H[®] TECHNICAL BULLETIN INTRAAX[®]/VANTRAAX SUSPENSIONS

NO: B43

SUBJECT: AA250 Air Spring Upgrade

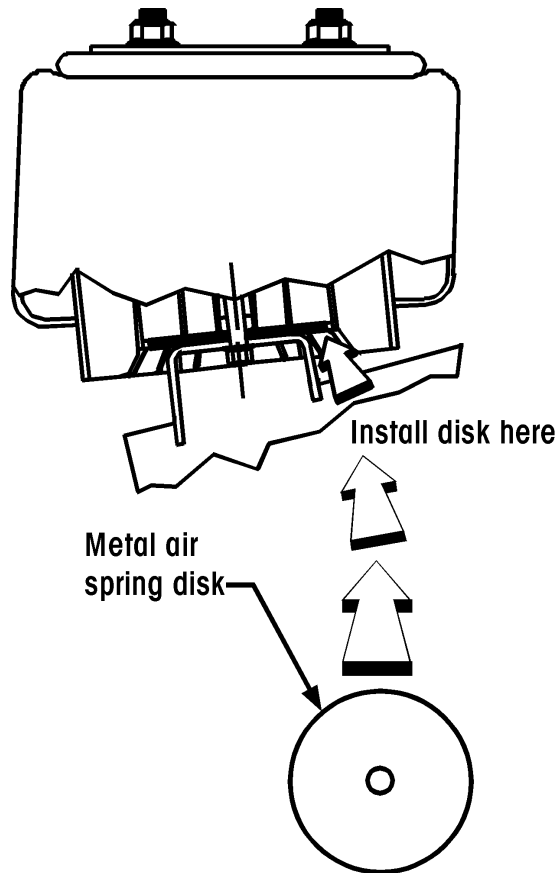
When installing or replacing the air springs on the AA250 (S-21784) INTRAAX[®] Suspension, the metal air spring support disk *must* be installed.

Tighten the air spring fasteners:

- Upper Air Spring Nut: 80-100 ft-lbs (108-136 N•m)
- Lower Air Spring Nut: 25-35 ft-lbs (34-47N•m)
